**ROCKY MOUNTAIN ARSENAL**

FINAL  
TECHNICAL PLAN  
VERSION 3.1

TASK NO. 10  
SEWERS AND PROCESS WATER SYSTEM INVESTIGATIONS

TASK NO. 10  
SEWERS AND PROCESS WATER SYSTEM INVESTIGATIONS

## FIGURE 3.5-4 Investigative Program South Plants Chemical Sewer System

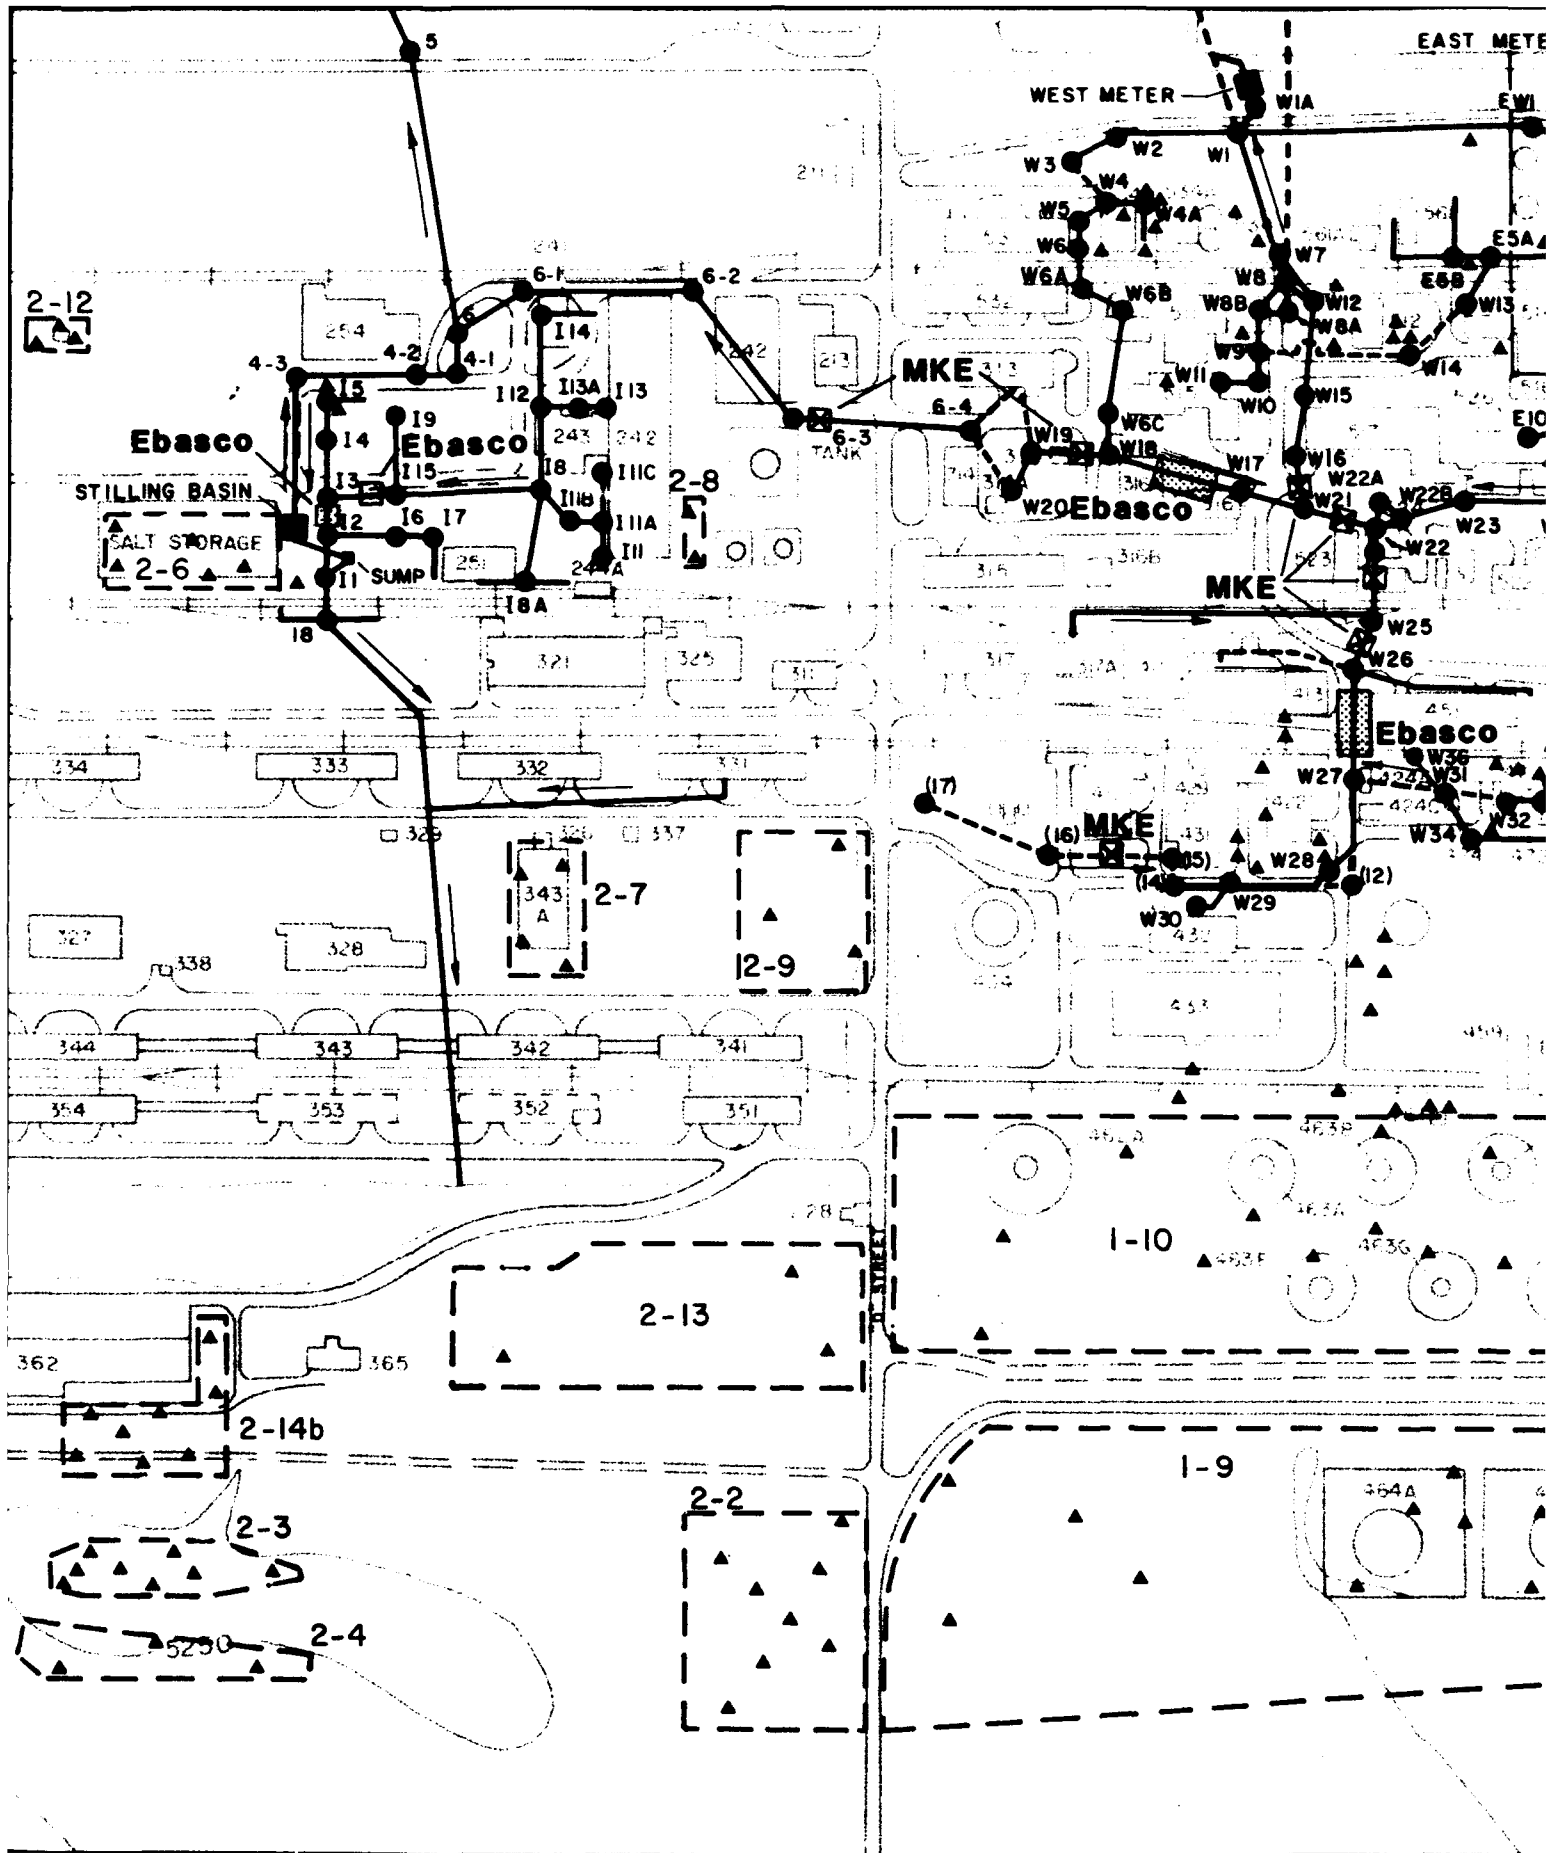
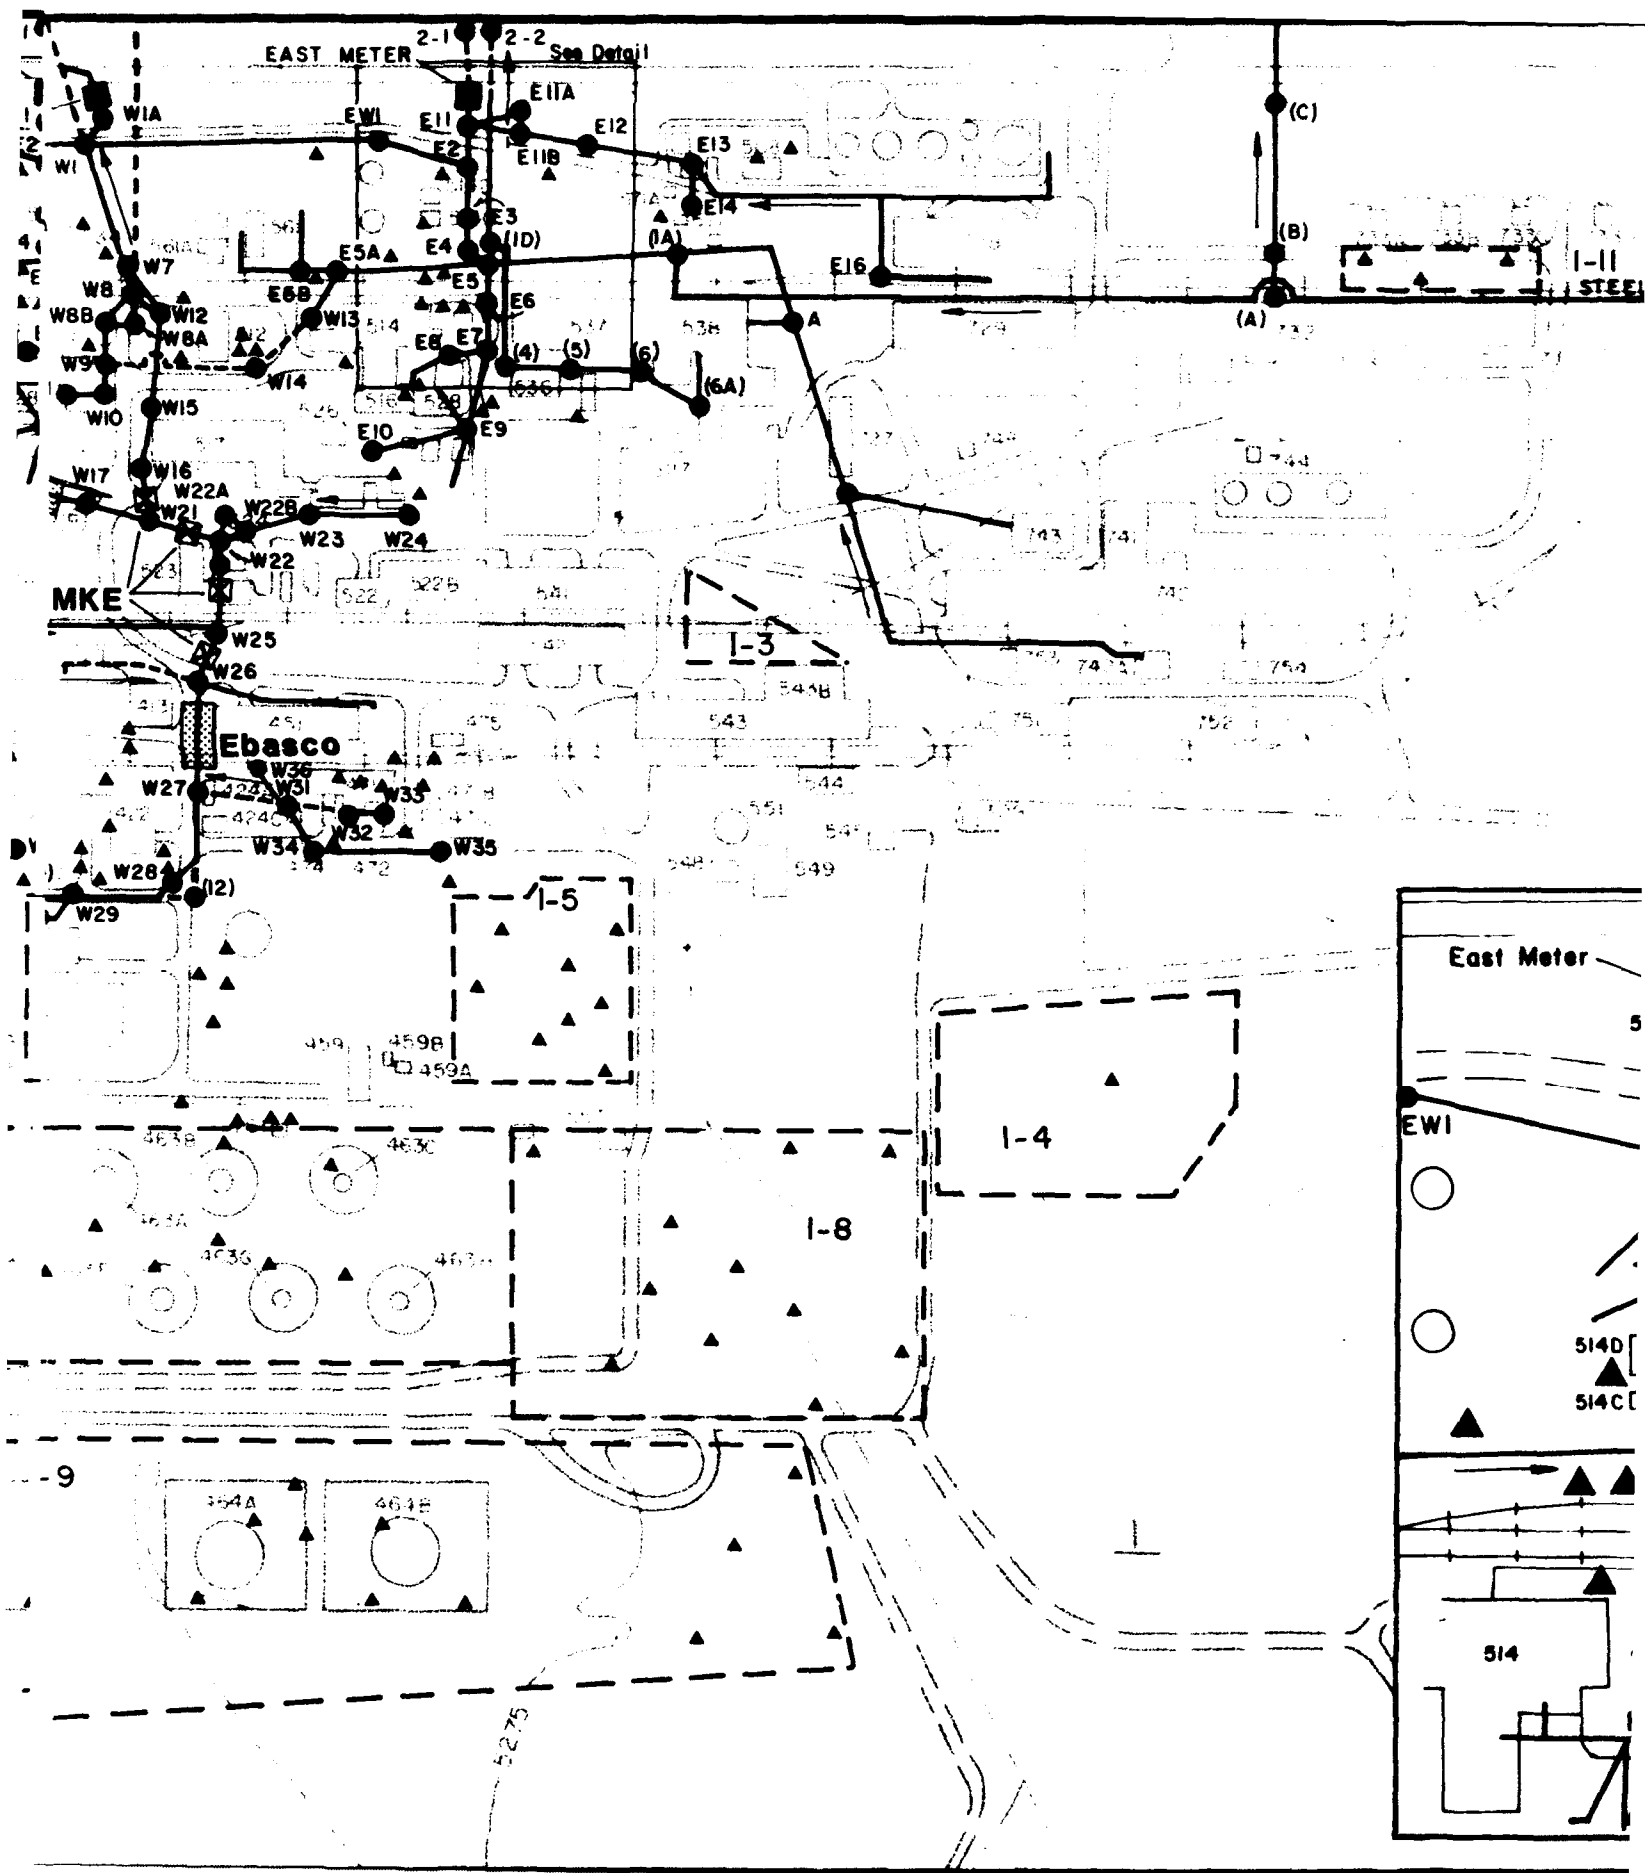
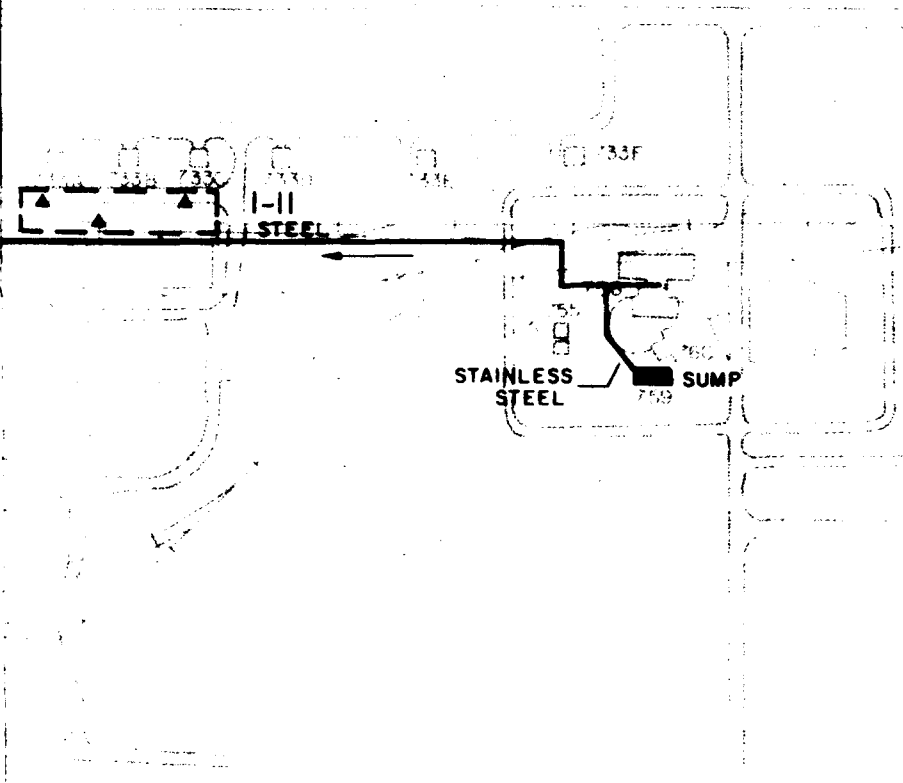
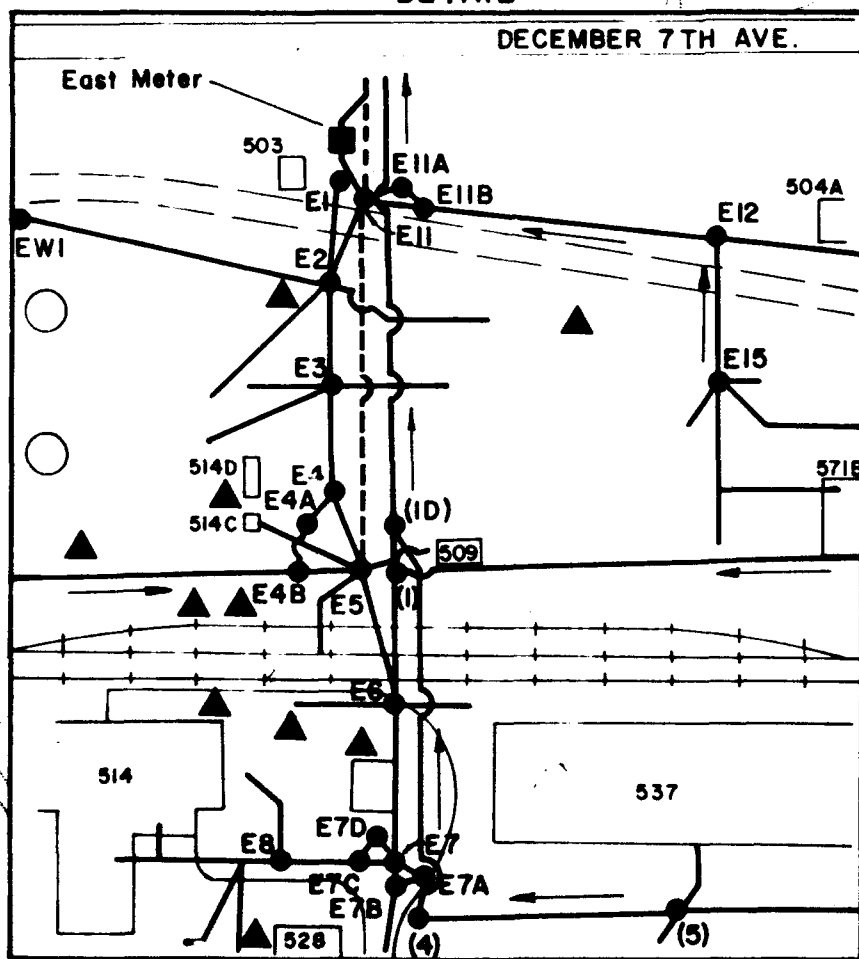
Page 3-47, Figure 3.5-4, and Page 3-48, Table 3.5-1. The Technical Plan proposes to investigate beneath manholes (A), (B), and (C) north of Building 732. These manholes are of precast concrete construction dated in 1953, and according to the George Donnelly, were never used. They are not representative of the significantly more numerous deteriorated contaminated sewer manholes in the South Plants and will mislead investigators if they are considered in any way "typical."

FIGURE 3.6-9

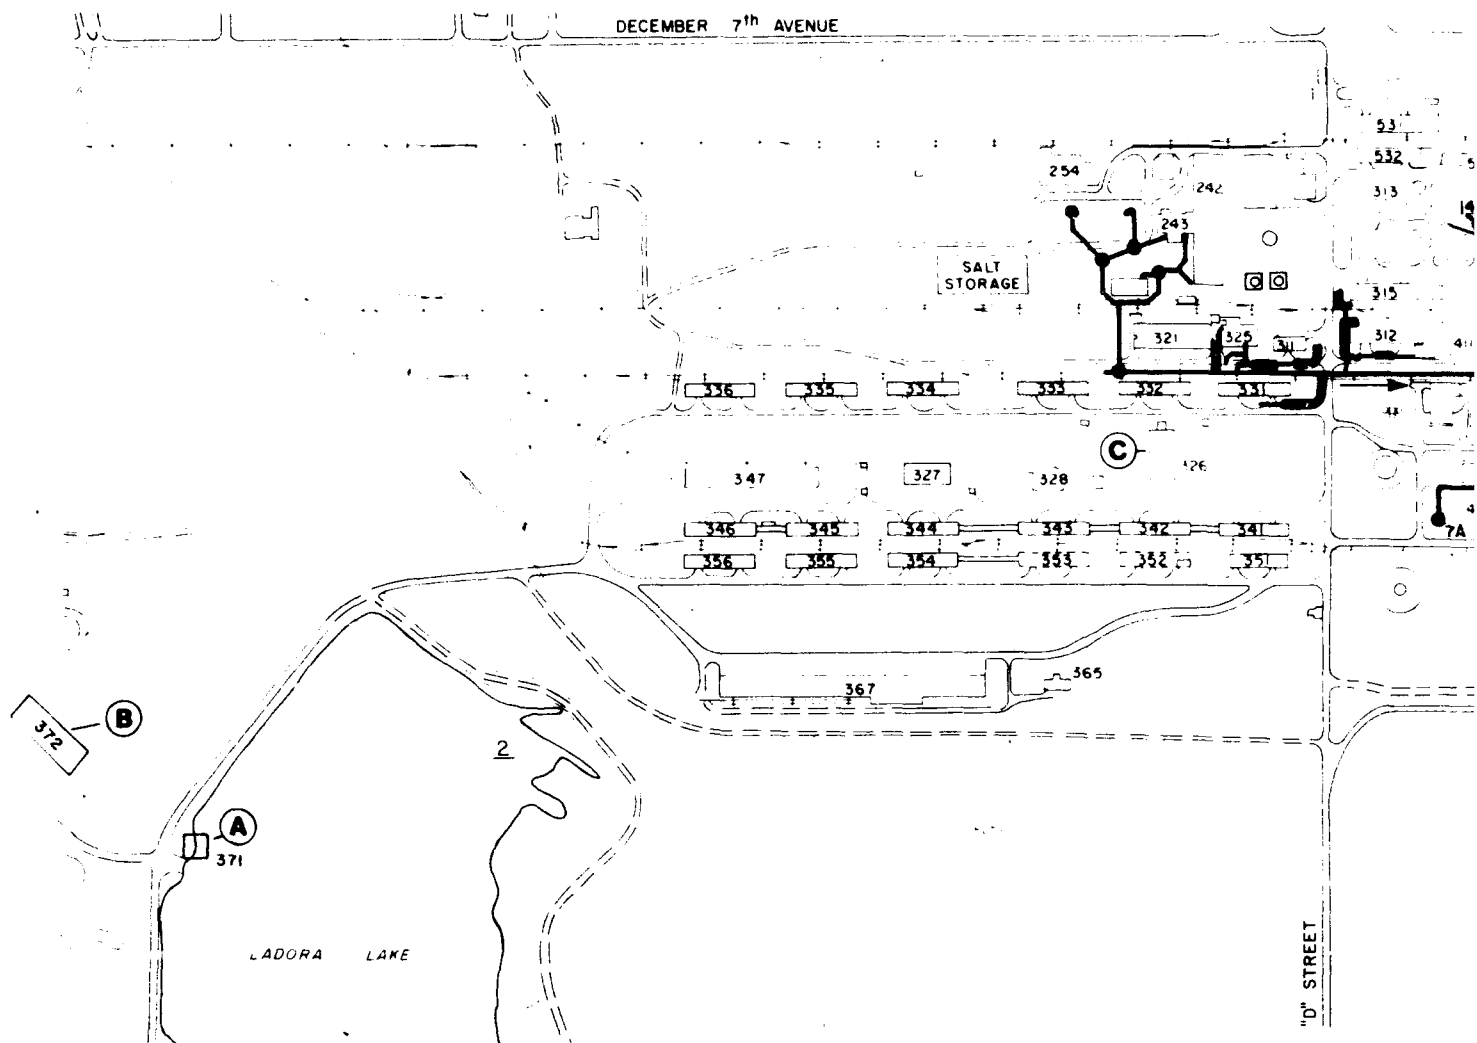
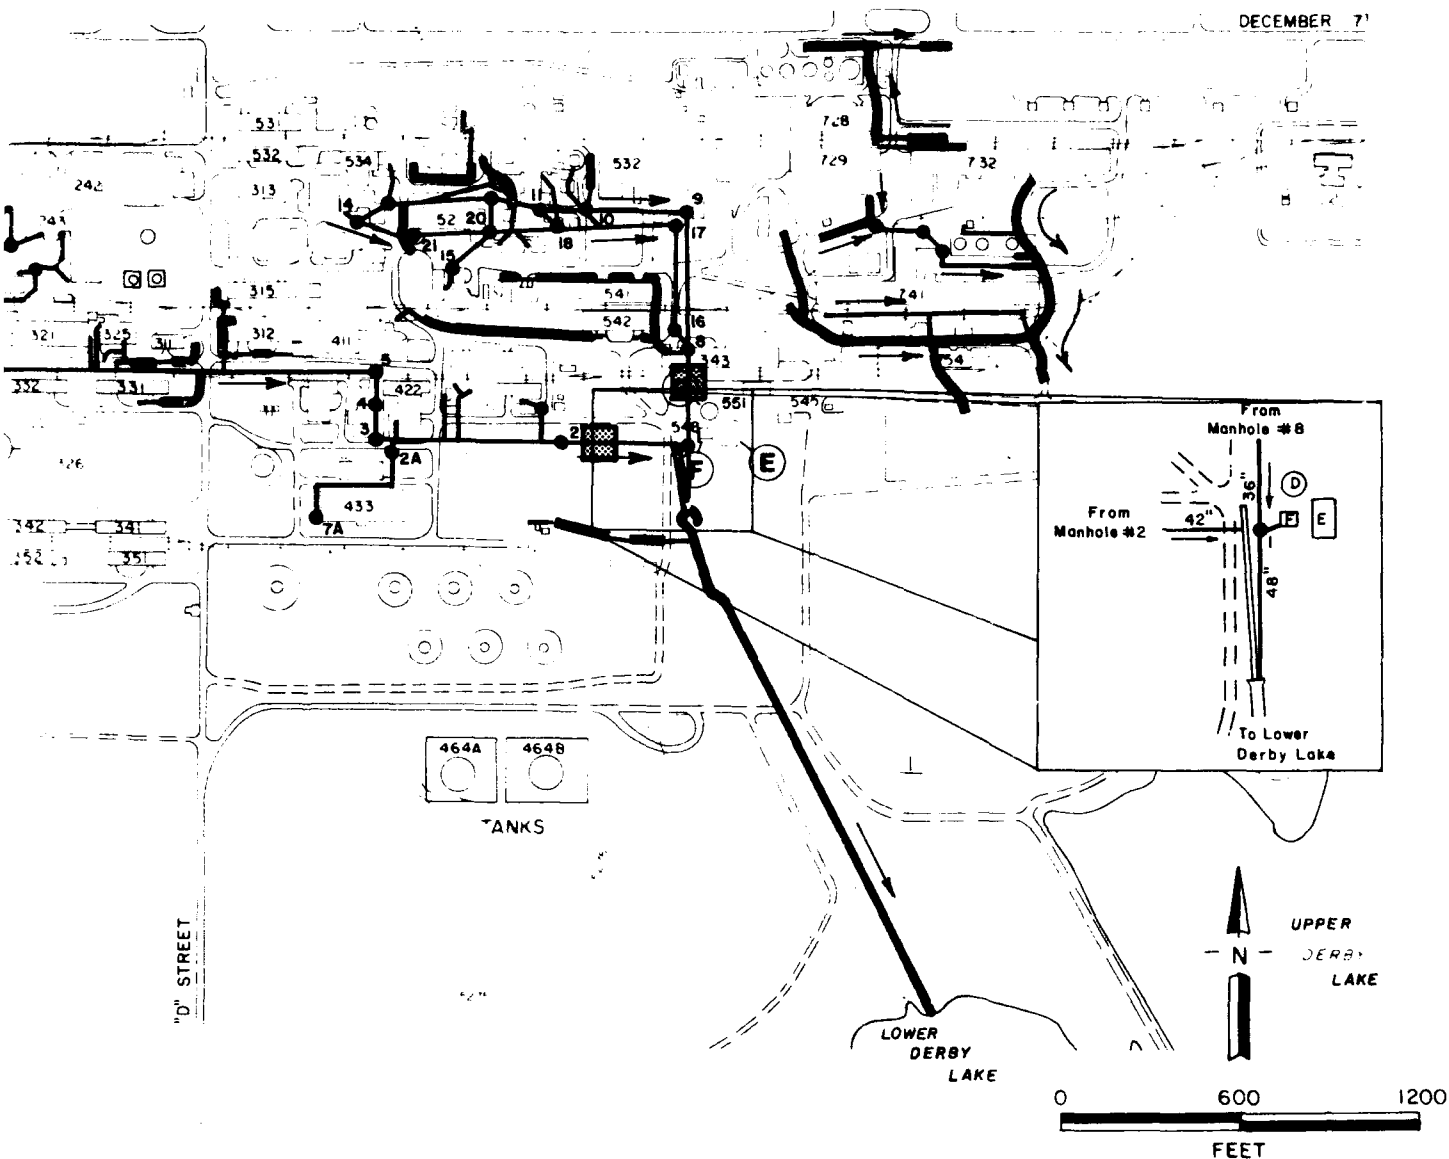
30. Comment: Page 3-61, last sentence, and Page 3-68, Figure 3.6-9.  
It does not necessarily follow that contamination should be suspected in the soils underlying the process water return lines simply because water was routed through them. More importantly, however, these two large diameter lines (36 to 42 inches) are not representative of the overall system, and therefore, any leakage patterns determined by the dye method could not be considered "typical."
